GJS Plot F, Manchester

Non-material Amendment | 25.09.2024

Z1-SHP-A180-RP-XX-NMA02 | P05

Updated Proposal - F1-SHP-G200-PL-Grd-B5D801 - P05

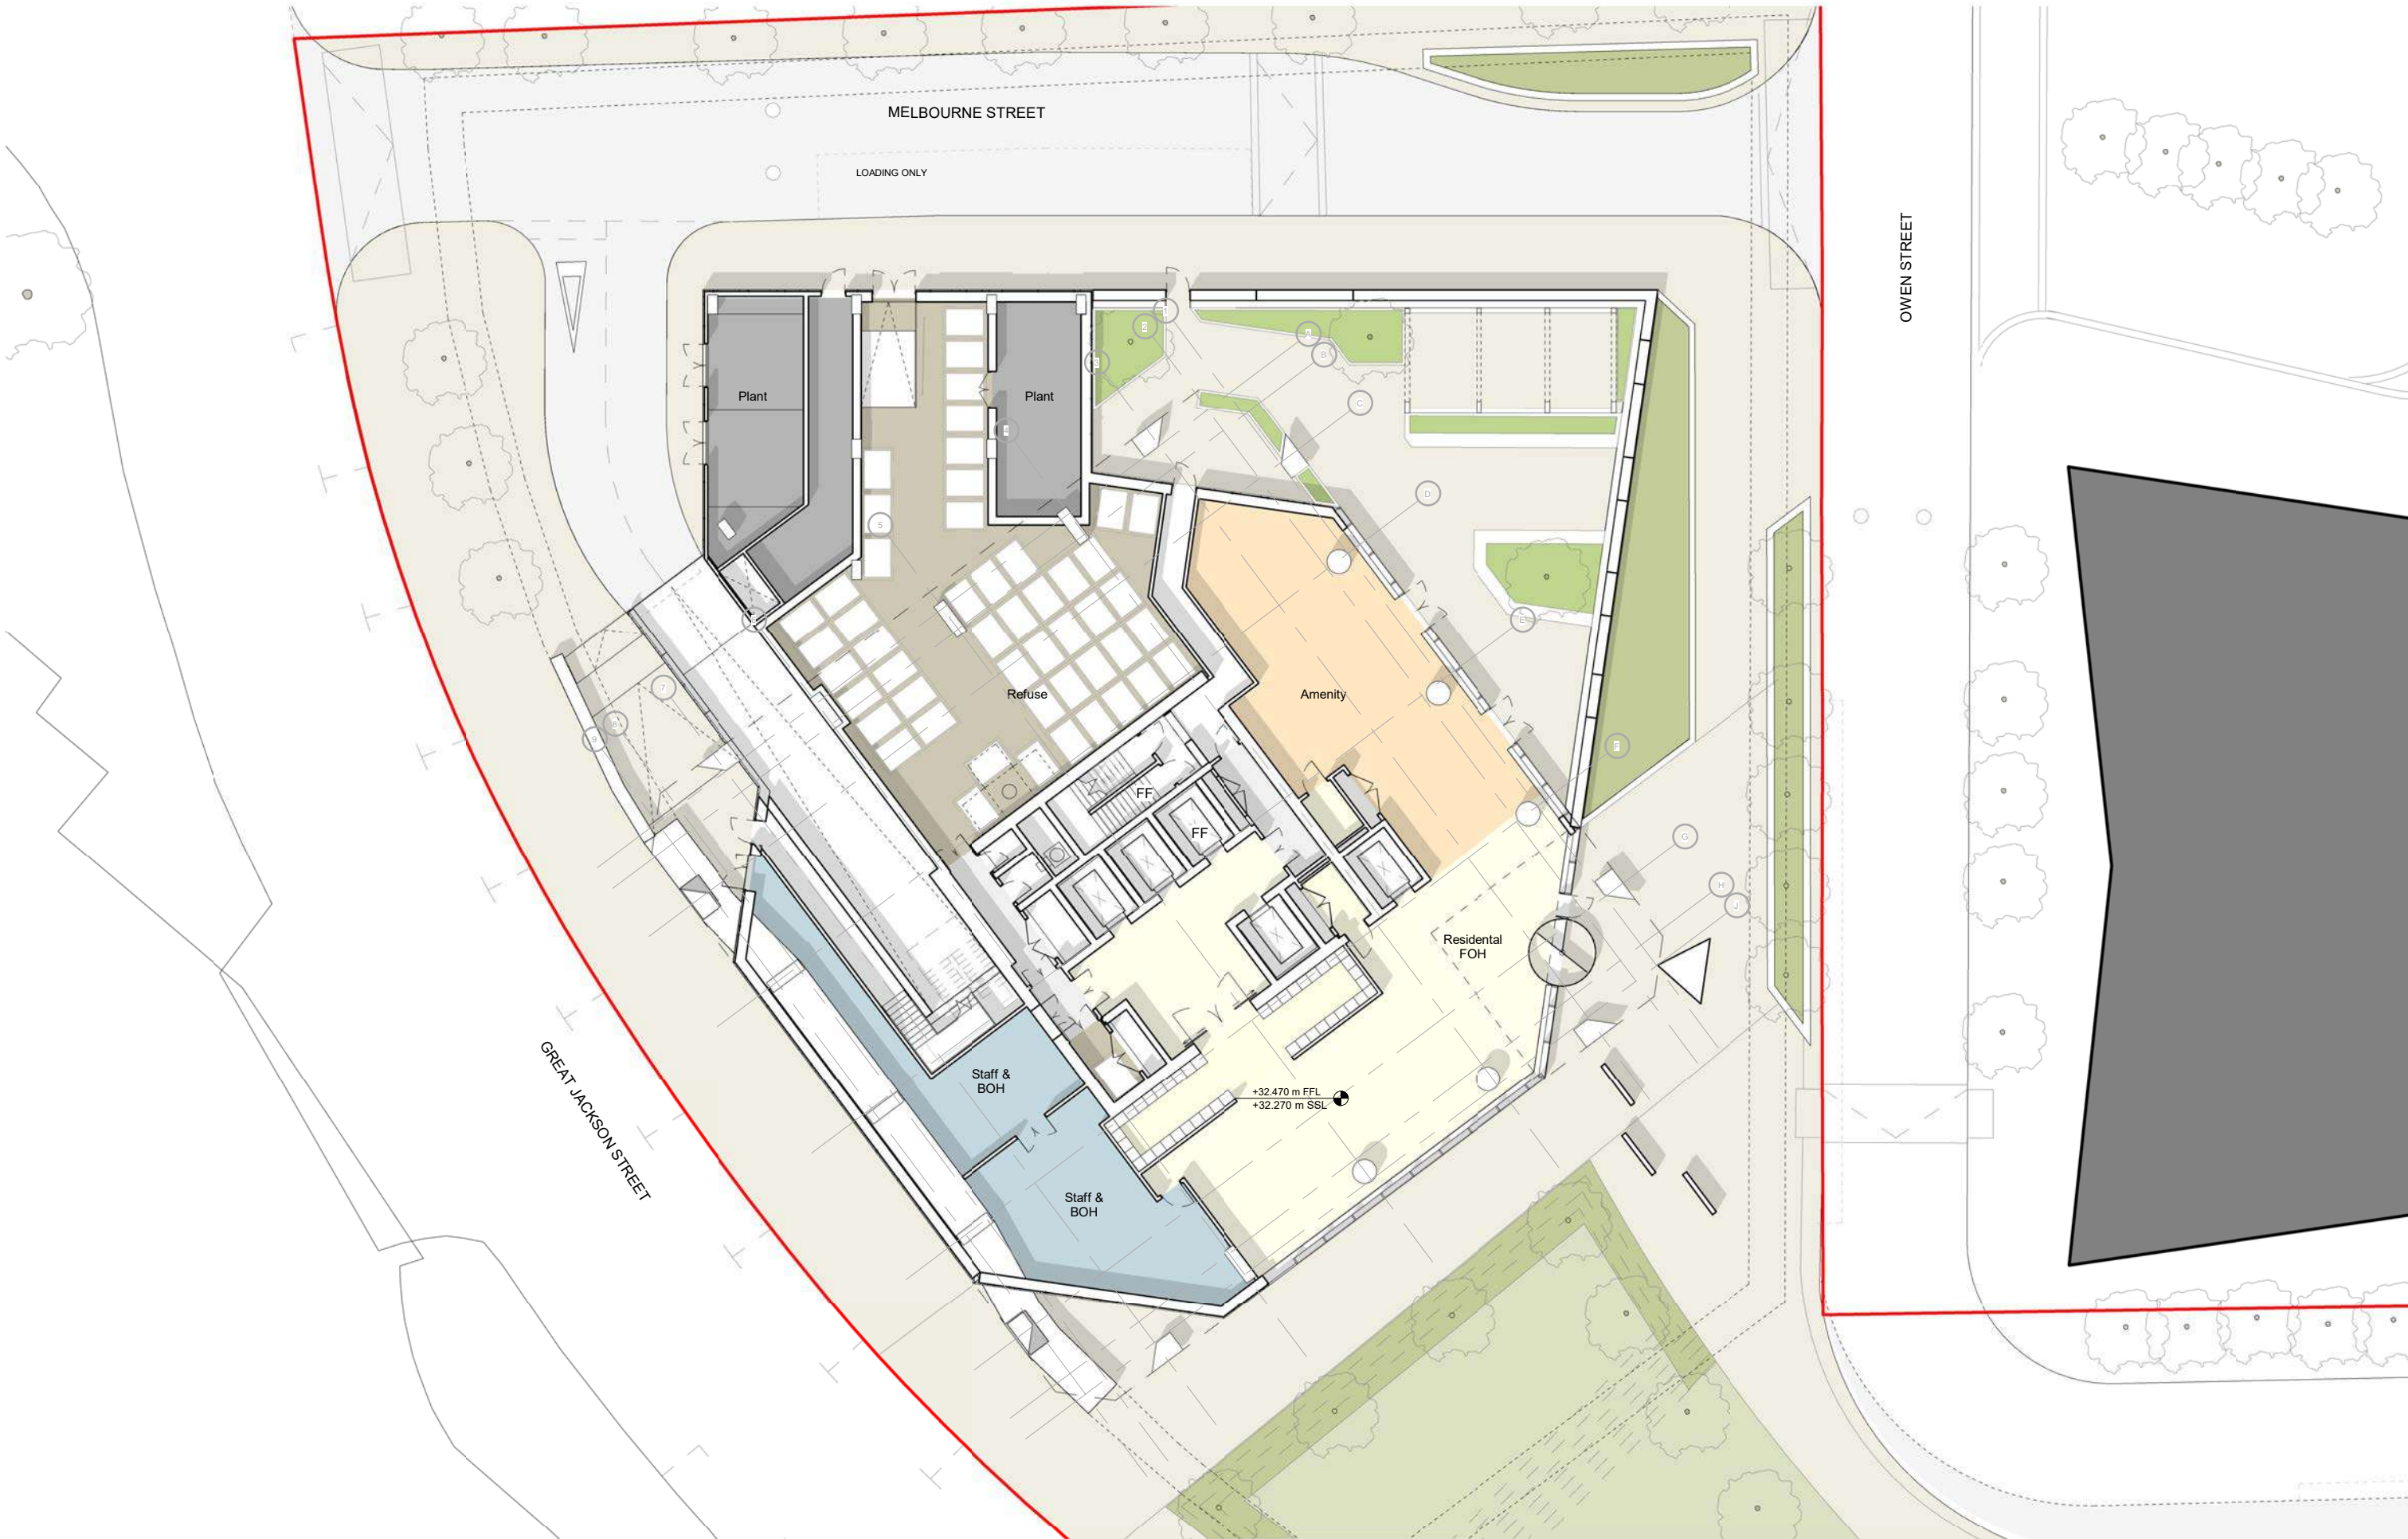
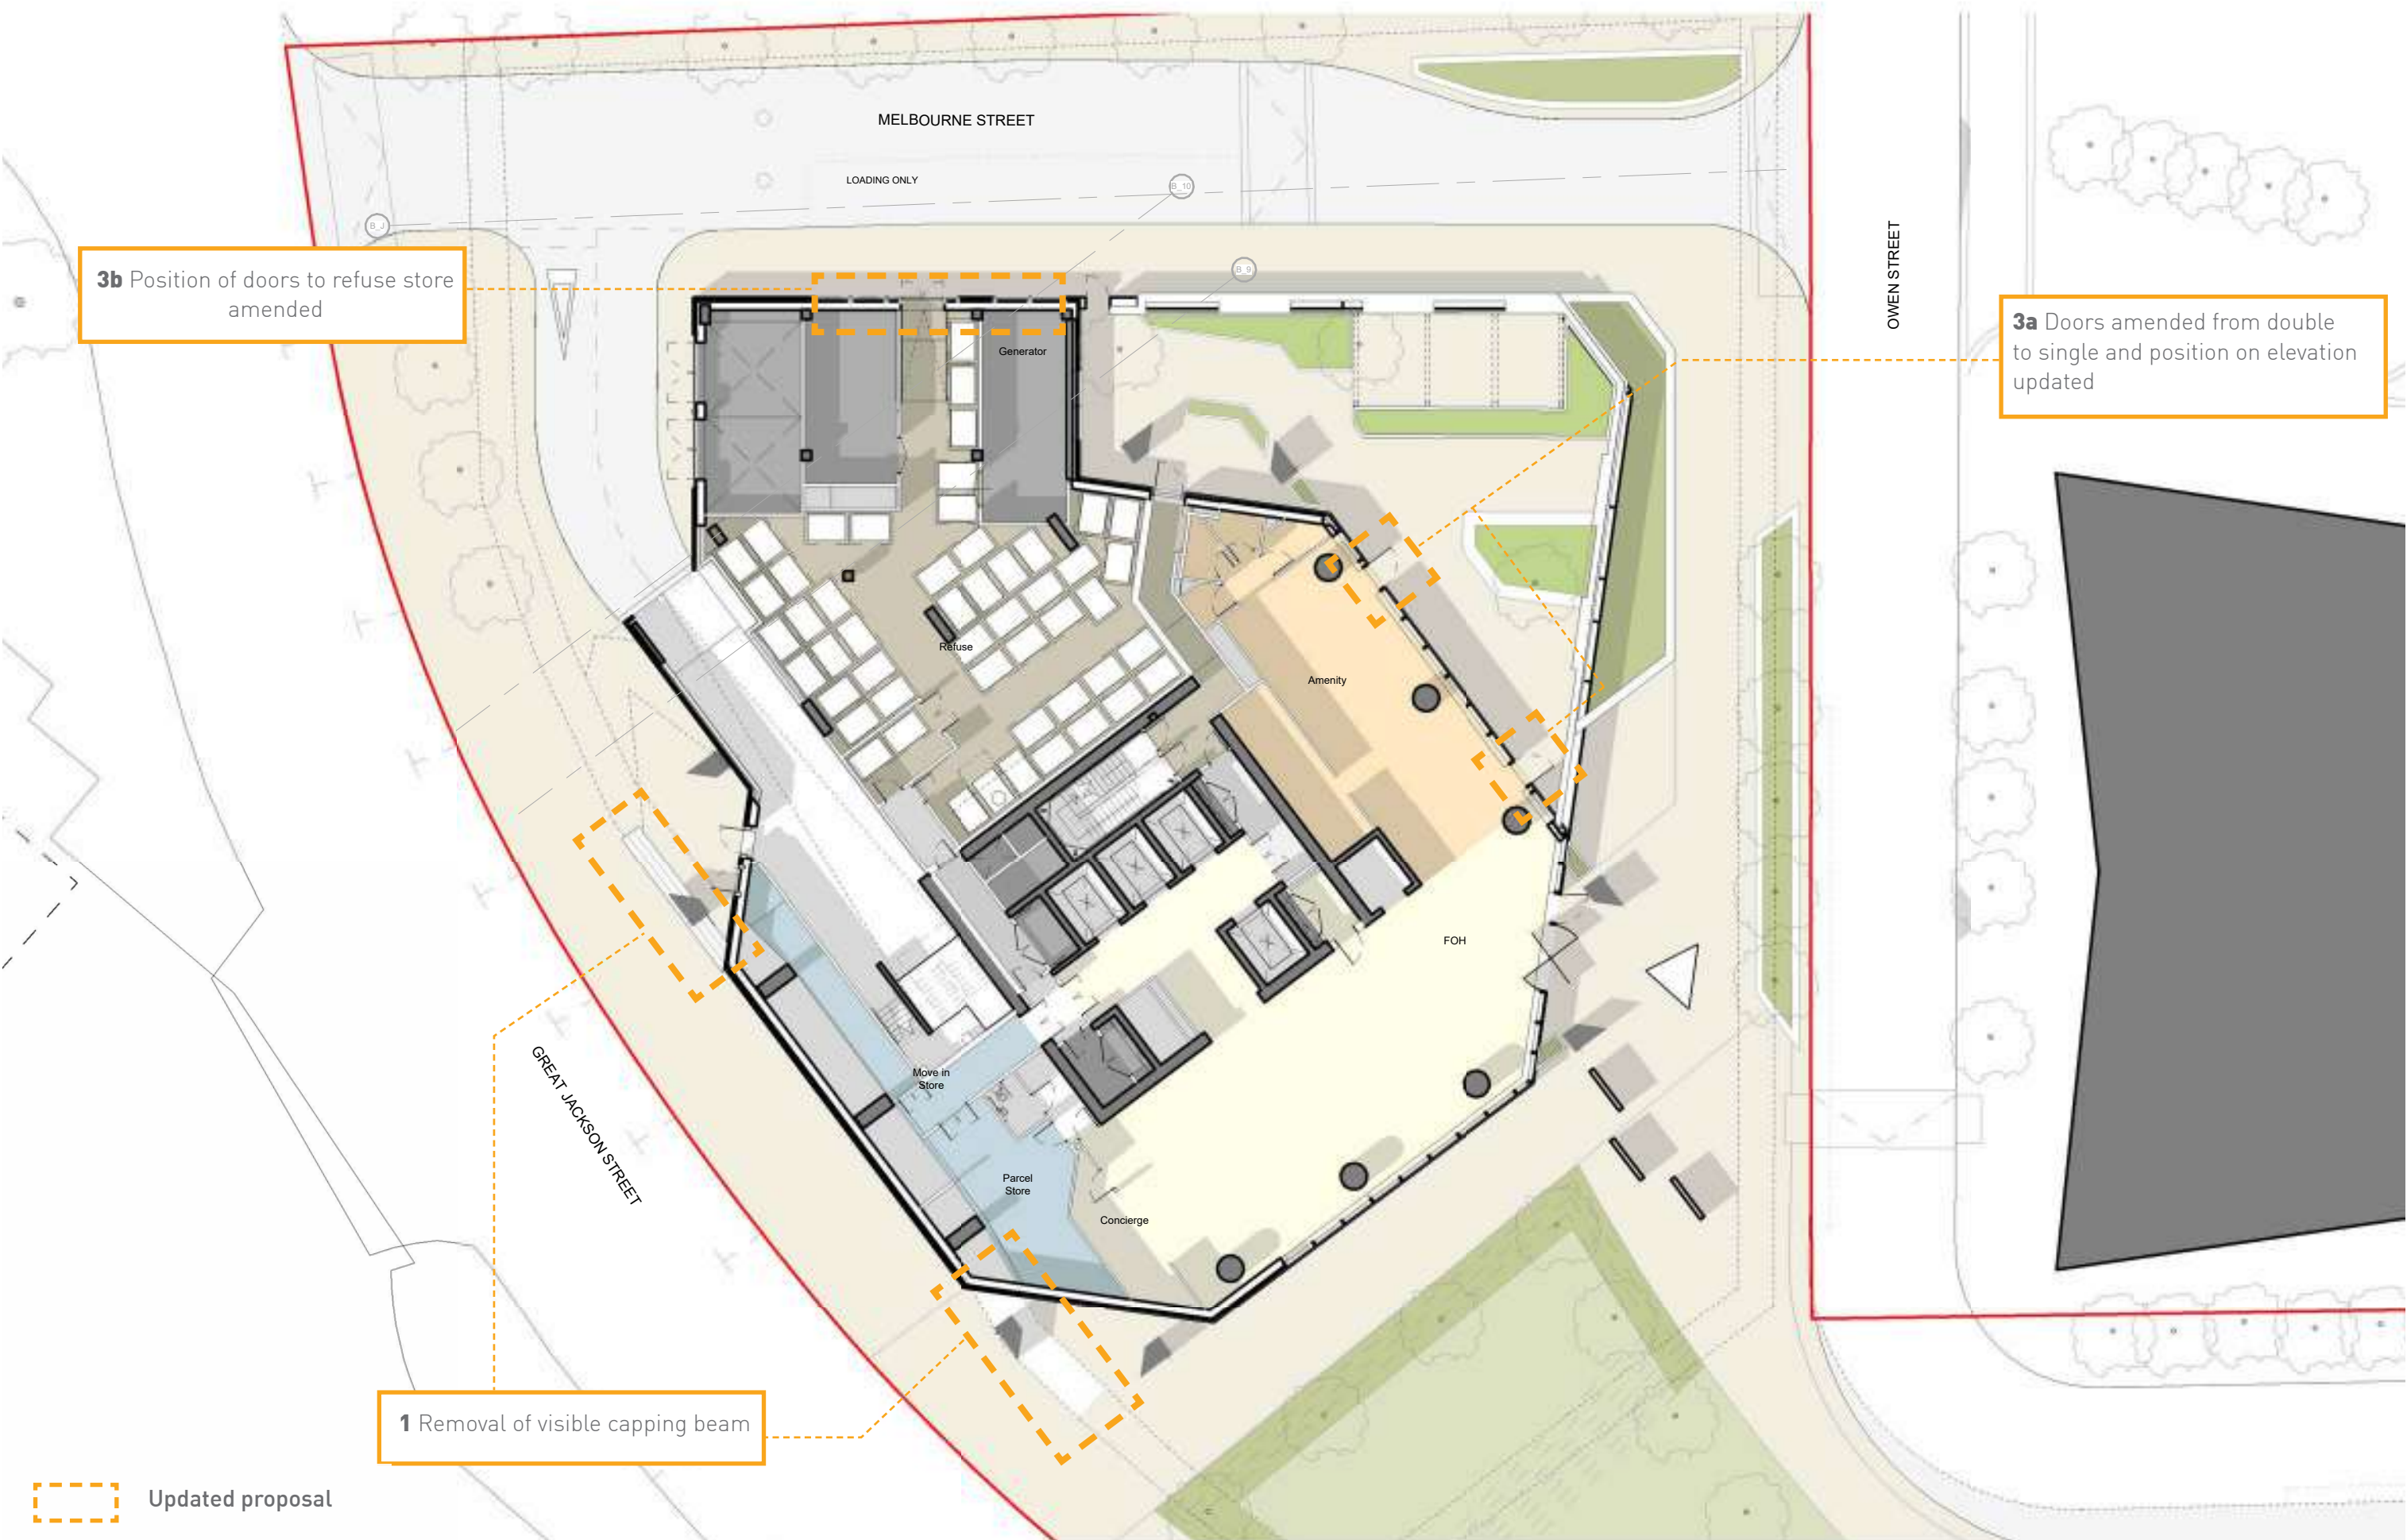
3.	External doors positions amended / design updated a. F1 - Doors to residential amenity In order to provide a more successful interior layout, the two double doors on F1 have been amended to large single leafs and spaced further apart to provide a more usable internal space, whilst maintaining a symmetrical elevation. b. F1 - Doors to refuse store / car park smoke extract Due to the incorporation of the perforated screen in front of the car park extract louvres (as requested by MCC) on F1, it has been neccessary to revise the free area requirement for basement the car park extract system and adjust the door position to the refuse store accordingly. c. F2 - Escape corridor doors The clear width of the escape doors has had to increase to provide the neccessary width for escape. As such this would leave a narrow brick pier at the side of the door. Instead this has been replaced with a larger centralised door allowing the 1500mm panelisation of the facade to be more legible.
